Office Action Summary	Application No. 10/776,522	Applicant(s) MAKUTA, YOHEI	
	Examiner BRUK A. GEBREMICHAEL	Art Unit 3715

DETAILED ACTION

- Claims 1, 3-4, 6, 9-10, 12-13, and 16-22 are rejected under 35 U.S.C. 103(a) as being unpatentable over Caprai 6,251,015 in view of Ritchie 4,637,605.

FIG A

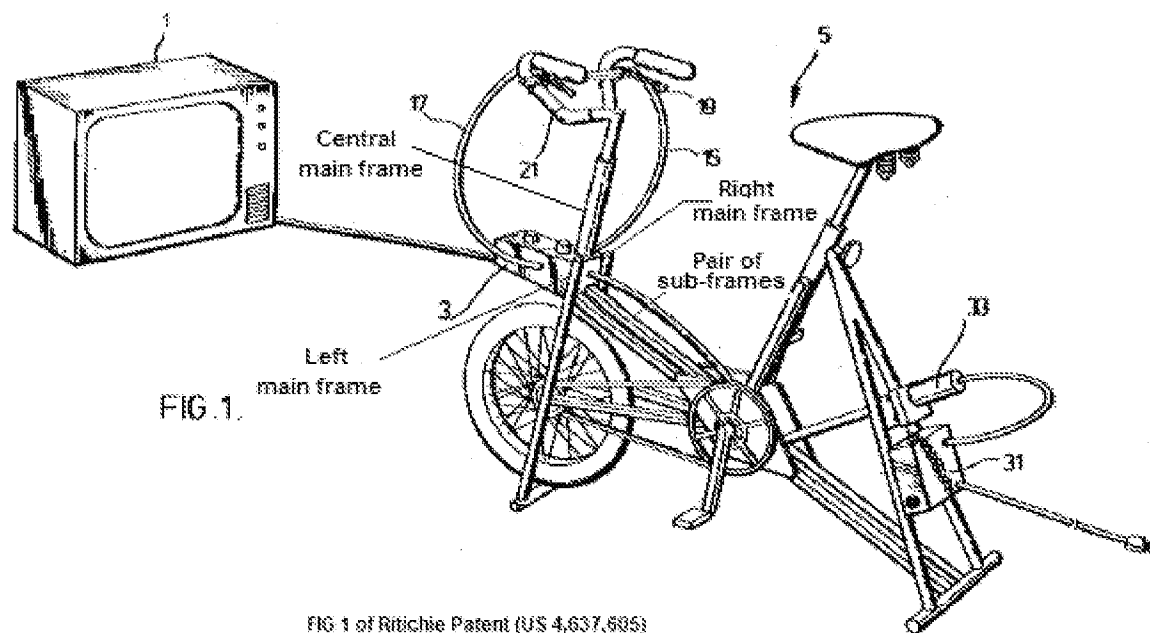
However, Ritchie teaches, a pair of left and right main frames, a centrally located main frame a pair of sub-frames connected to roughly central portions of the right and left main frames (see Examiner's annotated figure, FIG A which is based on FIG 1 of Ritchie's apparatus, label Pair of sub-frames), and a control unit for the system being mounted between the pair of left and right main frames and under the centrally located main frame (FIG 1, label 3 and also see FIG A regarding the Examiner's interpretation).

Ritchie further teaches, the casing of the control unit is disposed between a first main frame and a second main frame (see FIG A below with the Examiner's interpretation).

However, Ritchie teaches, a pair of left and right main frames, a centrally located main frame a pair of sub-frames connected to roughly central portions of the right and left main frames (see Examiner's annotated figure, FIG A which is based on FIG 1 of Ritchie's apparatus, label Pair of sub-frames), and a control unit for the system being mounted between the pair of main frames (FIG 1, label 3 and also see FIG A regarding the Examiner's interpretation).

However, Ritchie teaches, the end of the centrally located main frame is connected to a cross frame bridging between tip end portions of the sub-frames (see FIG A, the section i.e. back wall of the control unit where the end of the pair of sub-frames and end of the central frame are connected)

Regarding claims 20 and 21, Caprai in view of Ritchie teaches the claimed limitations as discussed above. Ritchie further teaches, a cylinder portion for receiving a steering stem, and wherein each of the right, left, and centrally located main frames has an upper end connected to the cylindrical portion (see FIG A below with the examiner's interpretation, the central frame, and the left and right main frames).

In response to argument (1), the control unit taught in Ritchie's reference is attached between the right and left main frames of the simulation system. Even though part of the

control unit appears to be in front of the frames, its attachment is between the two main frames, and therefore this structure teaches or suggests the broadest interpretation of Applicant's claimed limitation. In addition, the criticality or functional purpose disclosed in the Applicant's disclosure with regard to placing the control unit between the left and right main frames and under the centrally located main frame is to prevent the field of vision of the operator from being restricted (see Para.0057 and Para.0058 of Applicant's disclosure). It is also evident from the disclosure of the prior art (Caprai, FIG 1, label 14 and also Ritchie, FIG 1, label 3), the control unit does not appear to restrict the field of vision of the user. Thus, this functional limitation has already been suggested by the prior art, and as a result it does not distinguish the current invention from the prior art.
